Model: Martini-C1	Date: 13-Sep-02	No.: RB064002
-------------------	-----------------	---------------

Subject: Jogger Fence Adjustment		Prepared by: Y.Urushihara	
From: 1st Tech. Support Sec. Service Support Dept.			
Classification:	<input type="checkbox"/> Troubleshooting	<input type="checkbox"/> Part information	<input type="checkbox"/> Action required
	<input type="checkbox"/> Mechanical	<input type="checkbox"/> Electrical	<input checked="" type="checkbox"/> Service manual revision
	<input type="checkbox"/> Paper path	<input type="checkbox"/> Transmit/receive	<input type="checkbox"/> Retrofit information
	<input type="checkbox"/> Other ()

Model: Martini-C1		Date: 4-Oct-02	No.: RB064005
Subject: Finisher screw detaches from slide rail bracket		Prepared by: K. Miura	
From: Technical Services sec. Service Planning Dept.			
Classification:	<input checked="" type="checkbox"/> Troubleshooting	<input type="checkbox"/> Part information	<input type="checkbox"/> Action required
	<input type="checkbox"/> Mechanical	<input type="checkbox"/> Electrical	<input type="checkbox"/> Service manual revision
	<input type="checkbox"/> Paper path	<input type="checkbox"/> Transmit/receive	<input type

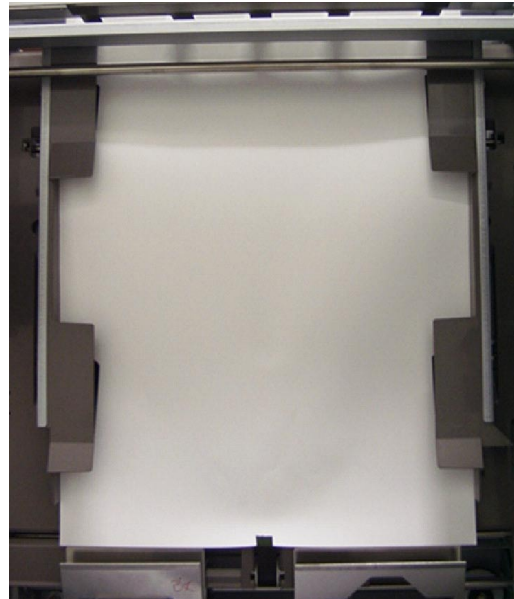
1. Move the belt hook down to the position shown in the photograph to the right by moving the stack feed out belt on the rear side of the unit by hand.

Important: Do not move the belt by the hook itself. Also, be sure to move the belt in the correct direction, shown by the arrow in the photograph below.

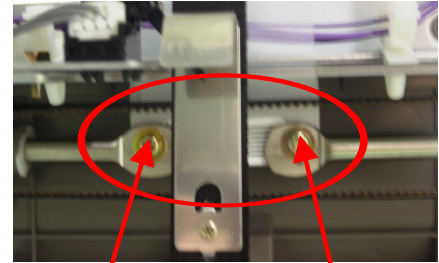
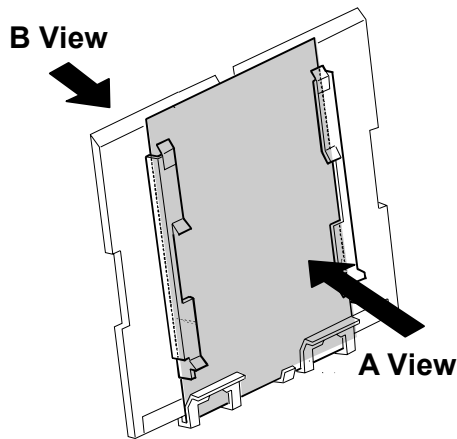
8. Adjust the **rear** jogger shaft position until the top edge of the upper stay and upper edge of the board are parallel to one another.

Left edge height + Right edge height = **0.5mm or less.**

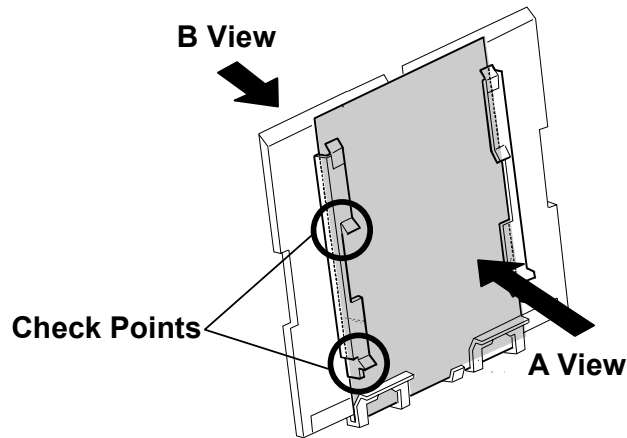
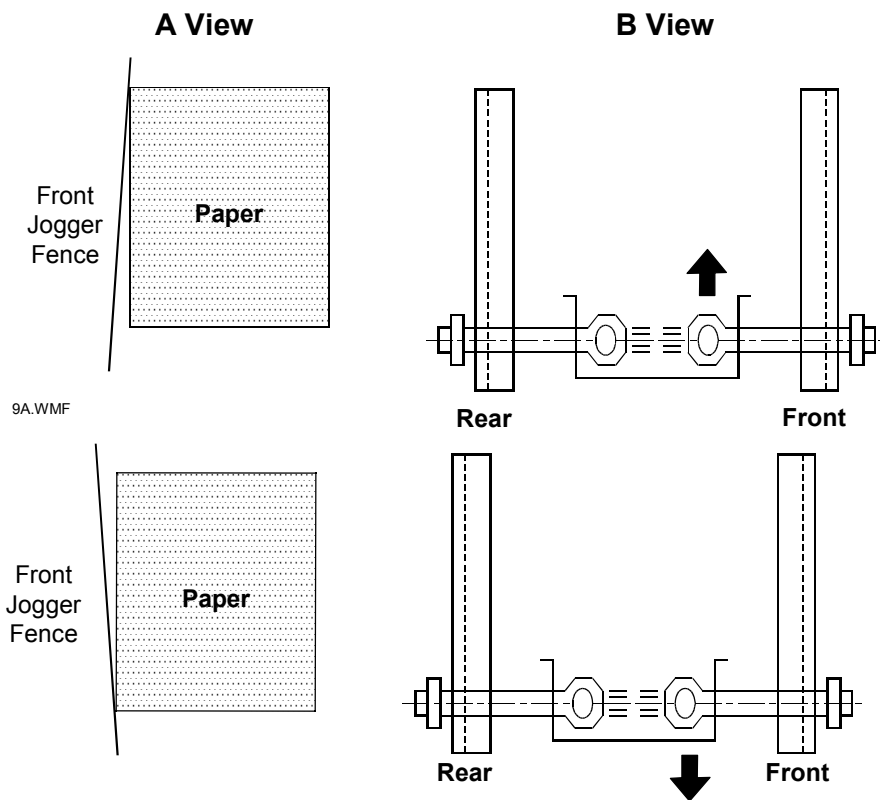
10. Bring the **front** jogger fence flush against the edge of the board, then adjust the front fence shaft until the board/fence gaps on both sides are:

Board/fence gap (top + bottom) = **0 - 0.5mm**.

13.WMF

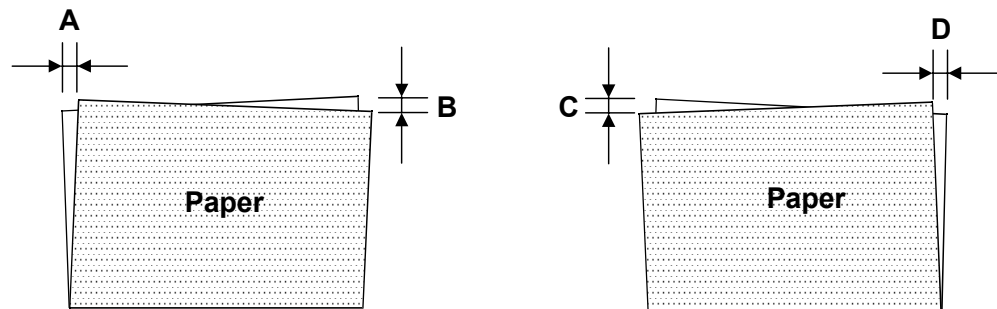
12. Print out 3 Booklet sets (2-3 sheets each) and check for folding skew.

All distances shown below (A, B, C, D): **2mm or less**.

Note: As mentioned on pg. 1, measure this from the edges of the **innermost sheet**.

13. If A, B, C or D is **over 2mm**, perform the following.

- A. Open the finisher front door, then insert a driver or other tool into the door switch to create the door-closed condition. Also, make sure to push in the stapler unit.
- B. Print out 3 Booklet sets (2-3 sheets each) using the exposure glass (not the DF).
- C. Once the paper is fed into the stapler unit and the machine stops operation, pull out the stapler unit.
- D. Press the “#” key on the operation panel, and then pull out the driver from the door switch as soon as the jogger fences close in to the paper edges from the standby position (10mm outside the paper width).
- E. Check to see that the paper/fence gaps on both sides are:
Paper/fence gap (top + bottom) = **0 - 0.5mm**.

If the fences are positioned too wide or too narrow, adjust the gap to 0 – 0.5mm for the given paper size using **SP6120**.

14A.WMF

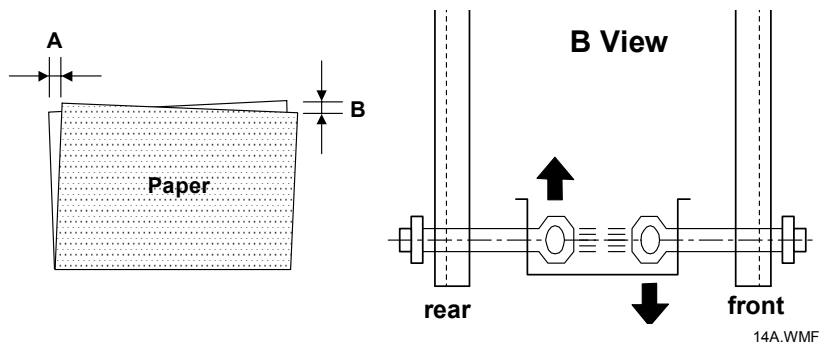
- 1) If A/B are over 2mm, **raise** the rear jogger fence shaft and re-secure the shaft in place. Then, loosen the screw for the front jogger fence shaft, **lower** the shaft to bring the front jogger fence flush against the paper, and re-secure the shaft in place.

14B.WMF

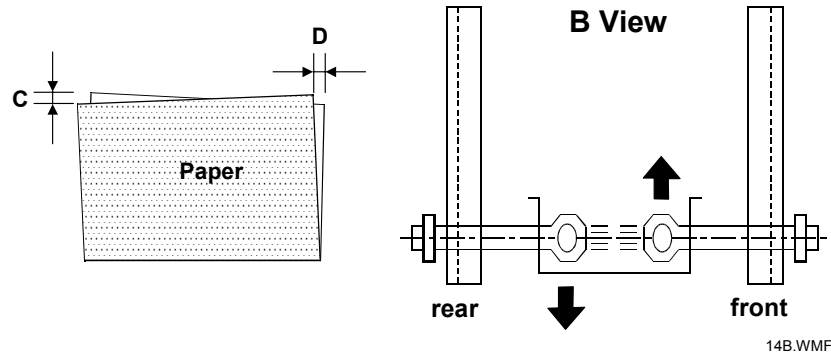
- 2) If C/D are over 2mm, **lower** the rear jogger fence shaft and re-secure the shaft in place. Then, loosen the screw for the front jogger fence shaft, **raise** the shaft to bring the front jogger fence flush against the paper, and re-secure the shaft in place.

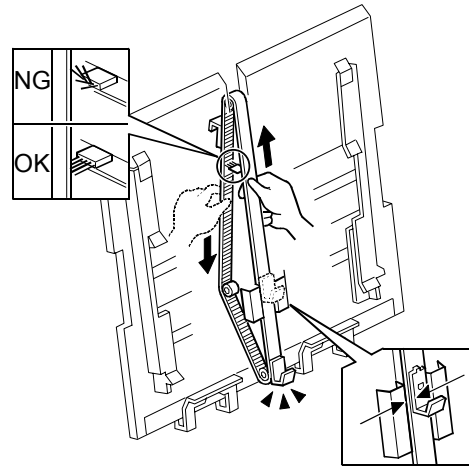
19. Bring the belt hook to the position shown in the photograph below then adjust the hook until it is parallel to the belt itself.

20. If the charge-removal brush is bent upwards, adjust it so that its fibers are perpendicular to the belt.

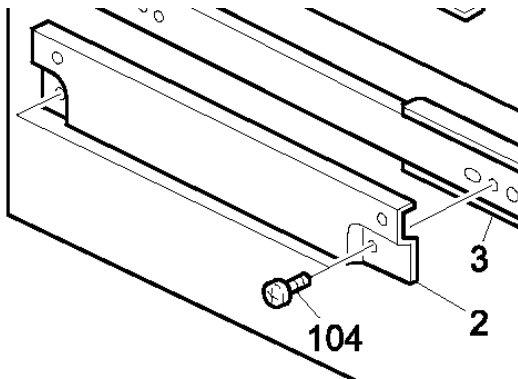
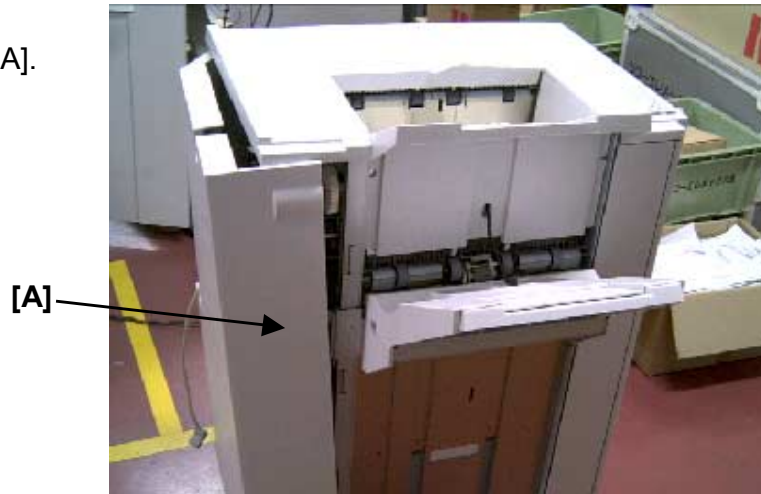
The screw shown below (Frame section 20, P/N #04533006B, pg. 45 #104) comes loose and detaches from the slide rail bracket.

Vibration during transport.

As a permanent solution, the screws have been equipped with spring-washers. As a temporary solution in the field, please perform the procedure below.

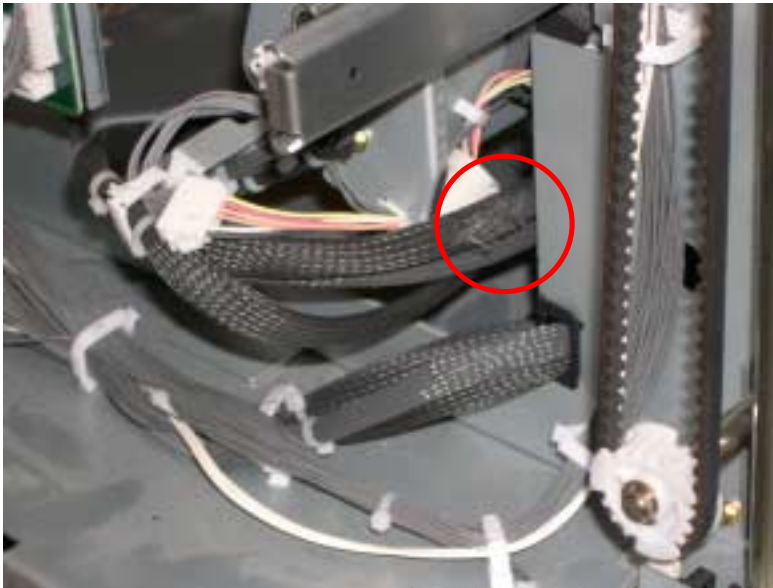
The outside of the stapler harness is damaged in the area shown in the photo. In some cases, a short circuit occurs in the damaged area.

The stapler harness rubs against the finisher rear plate when the stapler unit is pulled out or pushed in.

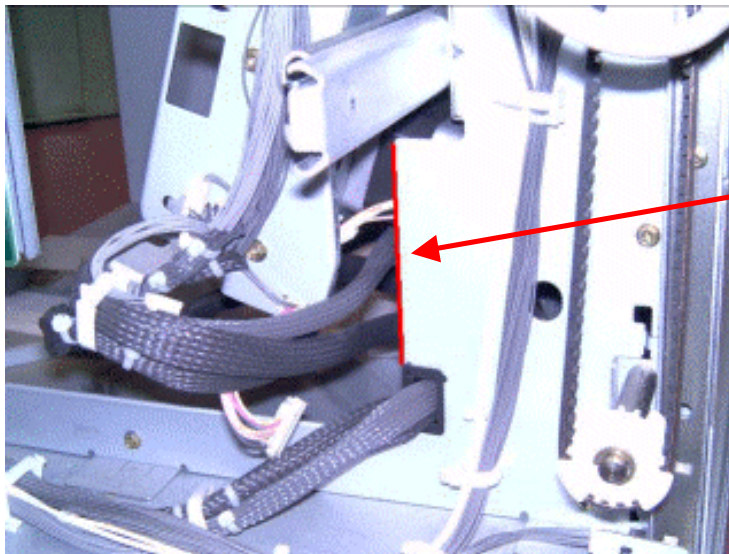
The shape of the rear plate has been changed so that it does not touch the stapler harness (the cut-in serial number is in the table below).

Attach a piece of insulating tape to the area of the rear plate shown in the photo (red mark).

**Attach the tape here****Cut-in Serial Numbers**
